RE: Administrative Plan No. 62020008A
Edgemoor Lots 20, 21 & P/O Lot 2

EDGEMOOR - LOTS 20, 21 & P/O LOT 2, BLOCK 8
ADMINISTRATIVE SUBDIVISION PLAN M-NCPPC
#62020008A

ADMINISTRATIVE SUBDIVISION PLAN #62020008A
FIRE DEPARTMENT ACCESS PLAN
5310 / 5314 MOORLAND LN. & 7507 GLENBROOK RD.
WSSC: 209NW05 MAP / GRID: HN12
EDGEMOOR-LOTS 20, 21 & P/O LOT 2, BLOCK 8
BETHESDA (7th) ELECTION DISTRICT
MONTGOMERY COUNTY, MARYLAND

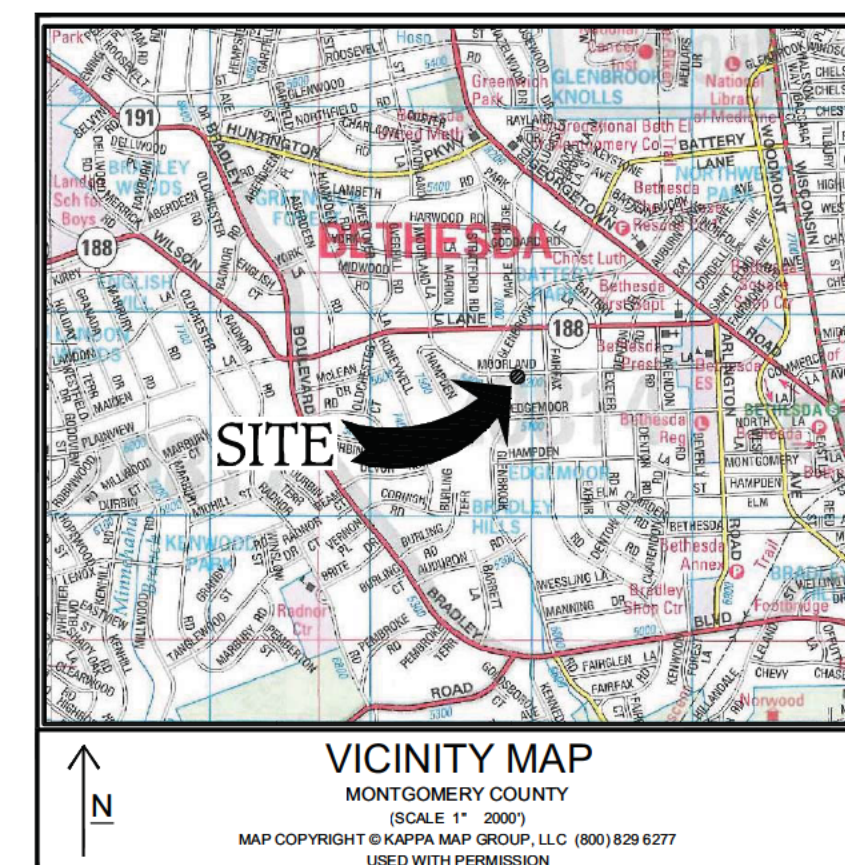
DATE: 13-Sep-21
TO: Rich Ingram - RIngram@cpja.com
Charles P. Johnson & Associates, Inc.
FROM: Marie LaBaw
RE: Edgemoor - Lots 20 21 & Pt. Lot 2 Block 8
62020008A

PLAN APPROVED

***** Detached single family unit is height restricted *****
